BEFORE THE OFFICE OF ADMINISTRATIVE HEARINGS STATE OF OREGON
for the
OREGON ENERGY FACILITY SITING COUNCIL

IN THE MATTER OF THE
APPLICATION FOR SITE
CERTIFICATE FOR THE YELLOW ROSEBUSH
ENERGY CENTER

**INTERVENOR ALEXANDERSON'S EXCEPTIONS
TO PROPOSED ORDER ON MOTIONS FOR
SUMMARY DETERMINATION**

OAH Case No. 2024-ABC-06692

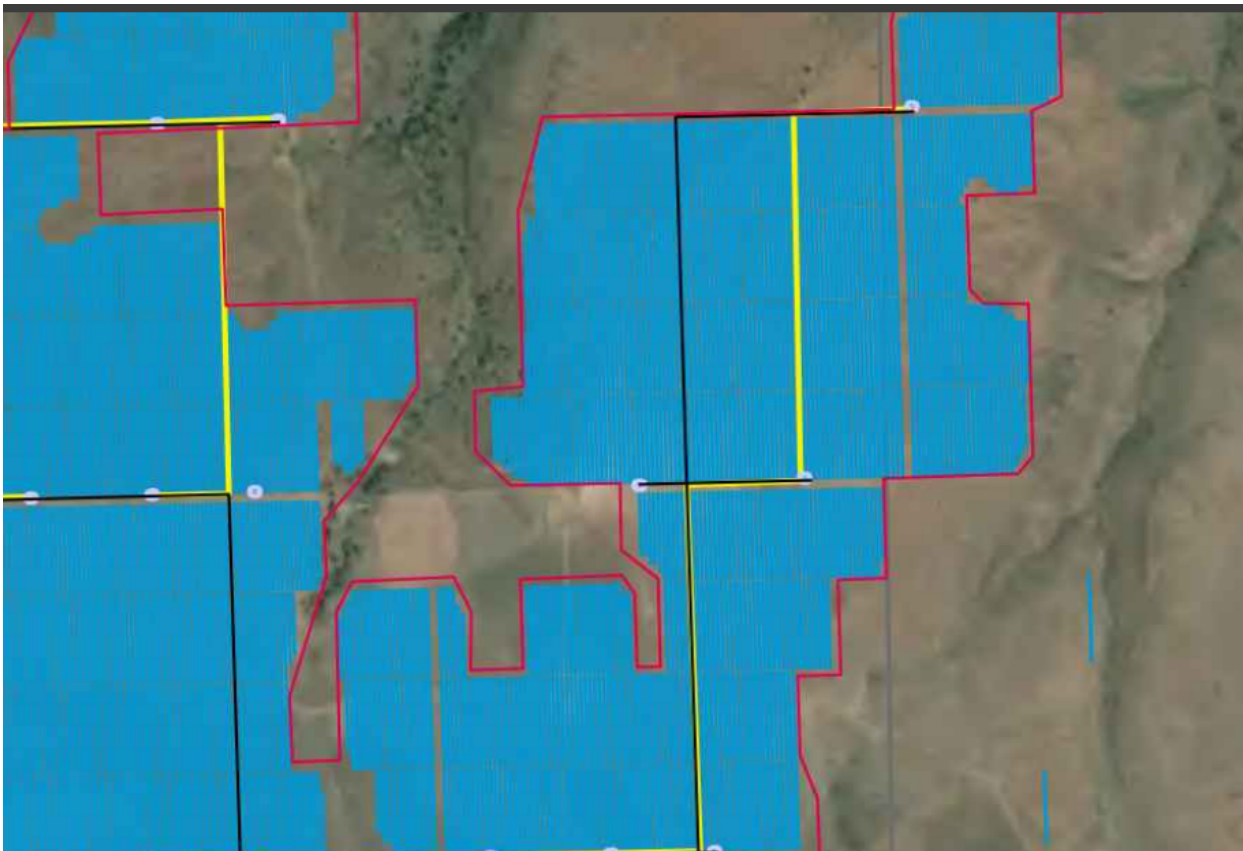
It is indisputable that the fence will have deleterious effects on both sides, even if it was open on both ends and didn't enclose land. Common sense and Intervenor's Affidavit and Response to MSDs posit that the combined fences of the three Bakeoven projects and proposed abutting Yellow Rosebush fencing leave only the Bakeoven road as a throughway. Going around is a large detour. See Exception 7.

The record of decision provides substantial evidence that harms from the fence affect outside the fence acreage and conditions. Consider land inside the project boundary, but outside the

fence, 8,075 (PO p.1) assuming 4,992 acres to be fenced out, there are 1655 acres proposed for mitigation and a remaining 1,428 to be outside the fence, inside the project boundary, not used for anything and not counted for mitigation. For purposes of this exception as an illustration see Figure 11 of the PO p. 144, partly reproduced below. It shows a side draw, leading to Buck Hollow Canyon. The red line is the fence and the blue area shows solar panels. Apparently the intention was to leave this draw open from the north so deer could come in from the canyon and use it. But fencing it on three sides with a bottleneck and three dead ends turns it into traps. Suppose some deer and their fawns are in there and a cougar or wolf follows them. What if a windblown wildfire is racing up the canyons?

Absent the fence the deer can use the land and escape in all directions. After the fence they will only have due North and a few degrees either side. Before the fence they could escape tall flames in the brushy canyons by running for the short grass or already burned areas of the plateaus. One hopes their instincts will keep them out of such situations. If so, the canyon habitat has been degraded. If not, their risk goes up of being eaten or burned, hence a different degradation.

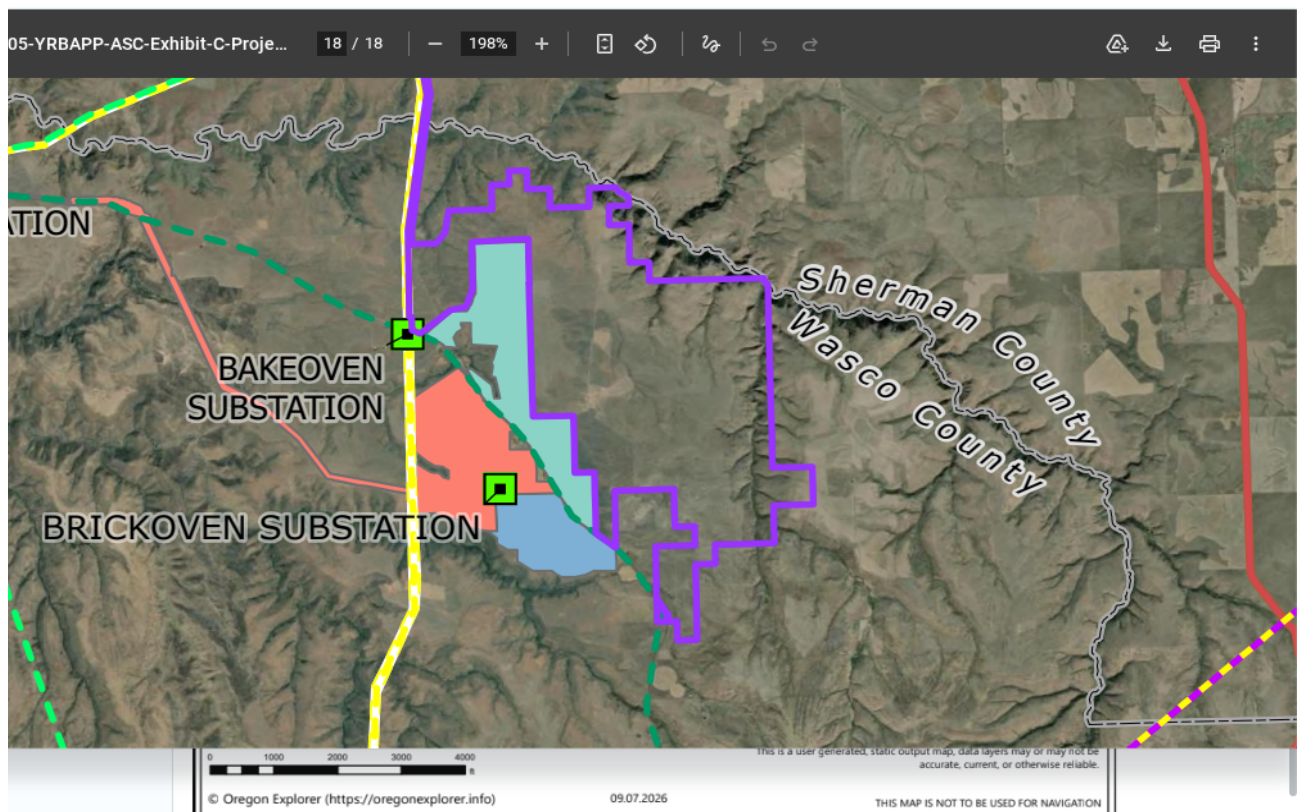
Intervenor raised the issue: “What are the cumulative effects considering the adjacent Bakeoven projects are already evicting the deer?” Alexanderson Comments last page, second to last paragraph. This issue is material because the project was sited to tightly wrap around the three approved Bakeoven projects, leaving no path between or through any of four projects except along Bakeoven Road.⁸ Common sense recognizes increased risk to deer if they are given only a public right of way to pass through. Vehicle collisions are a significant cause of deer mortality identified in the MDMP and Exhibit P. This hole in the case is an uninventoried uncompensated outside-the-fence habitat spoliation that precludes summary determination..

This shows the wrap leaving Bakeoven Road as the only throughway. The project boundary is purple. The YR fence line can be seen in the next image:

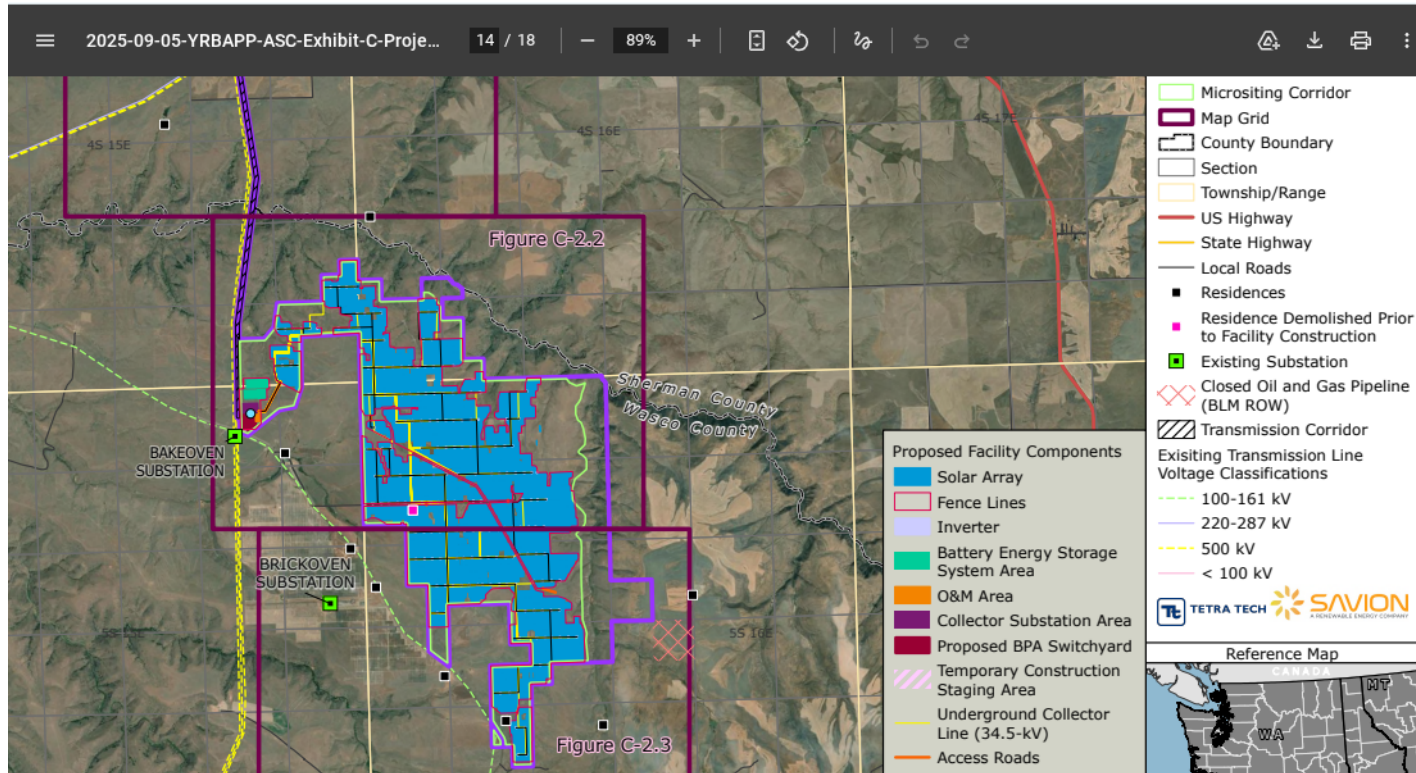
This view omits the Bakeoven projects and shows the fence line. For deer to go around they will have to circumnavigate all four projects. To go through they will only have Bakeoven Road.

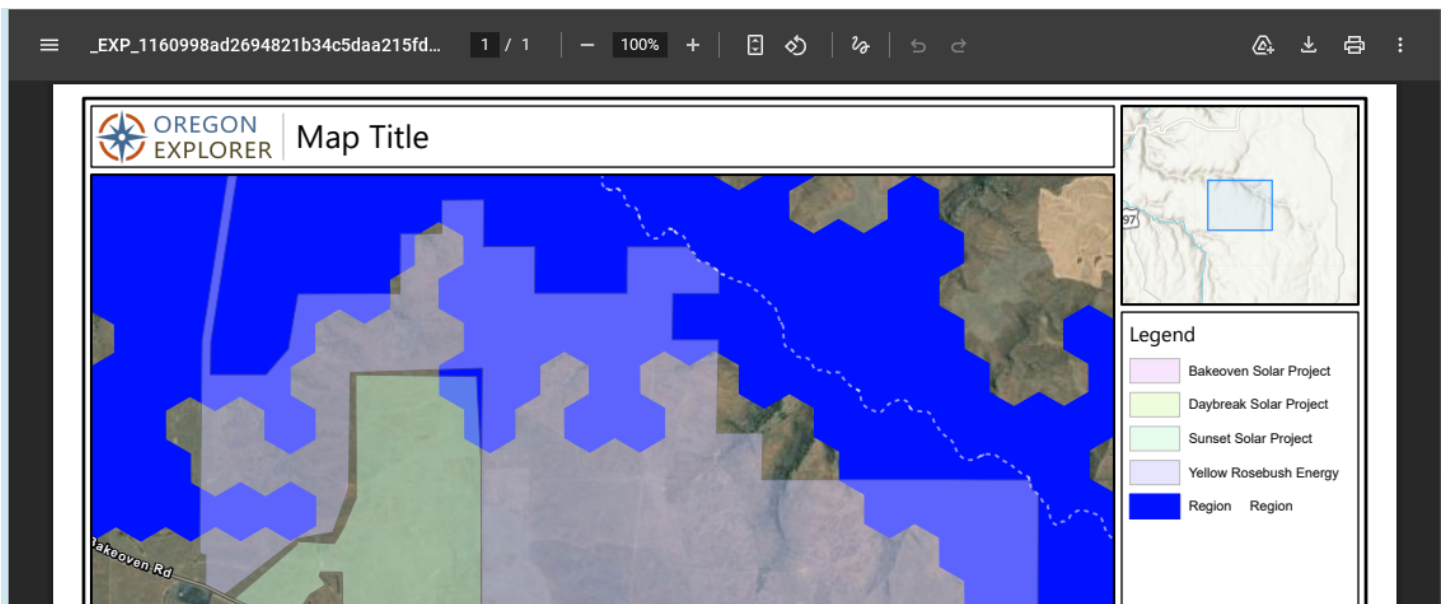
Dark blue is PWCA outside the project boundaries. Green is the Sunset (Bakeoven) approved project. The light blue is where the project boundaries include PWCA hexagons. For illustration only notice the NE corner of the green project and the light blue hexagons in the YR project adjacent to the east and north. Compare to the solar arrays below.

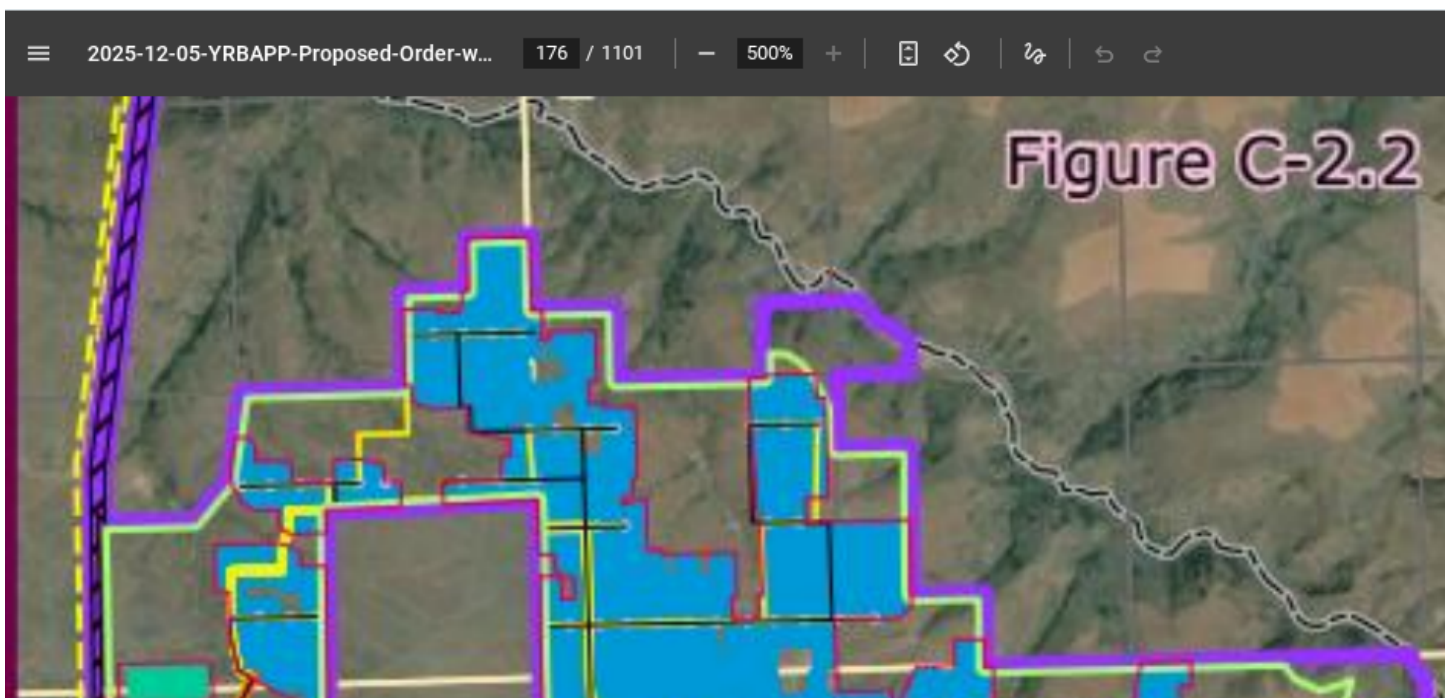
Here, the green project is shown as an empty square with YR's red fences. Blue denotes the YR arrays. Plainly some arrays and fences are planned to be installed in PWCA. No avoidance consideration is in the record of alternatives required by the Rule including "not taking a certain development action or parts of that action." OAR 635-417-0005(16)(a). Note also the dead end predator and fire trap just to the east.
